Broadcast Products Technical Bulletin 92-064

Model: BVM-1310/1315/1910/1912/1915

Subject: UNEVEN COLOR IN COMPONENT

Figure 1 Figure 2

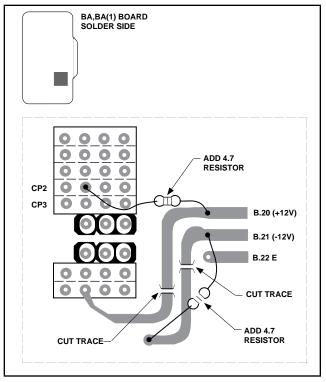
MODIFICATION PROCEDURE All Models BA, BA(1) or BA(3) Board Solder Side (See Figure 1 for BA, BA(1) Boards) (See Figure 2 for BA(3) Board)

- 1. Cut trace leading from B20 (+12V).
- 2. Cut trace leading from B21 (-12V).
- 3. Tack-solder two 4.7 Ω resistors (solder side) at locations shown in Figure 1.

Figure 3

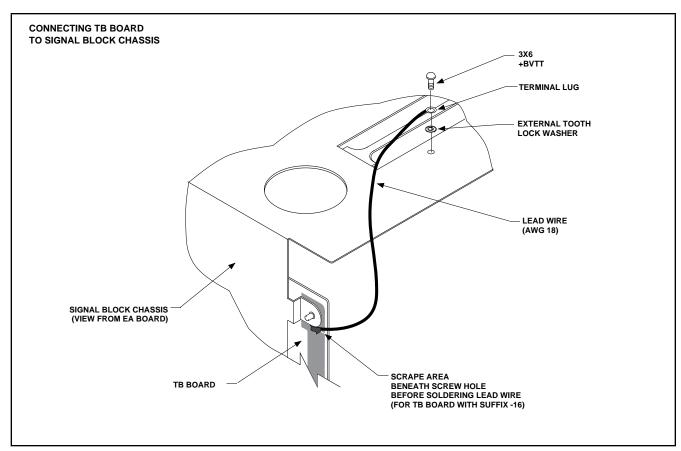
Additional Modification for BVM-1315/1915 (See Figure 3.)

- 1. Connect the TB board to the signal block chassis using a 90mm lead wire (AWG 18) with a 3mm diameter lug on one end. Use a lock washer (7-623-422-07) and 3x6 +BVTT screw to secure the lug to the chassis.
- 2. Solder other end of lead wire to the TB board. On PCB no. 1-617-899-16 (and lower) it will be necessary to lightly scrape the area beneath the screw hole to ensure a reliable connection.
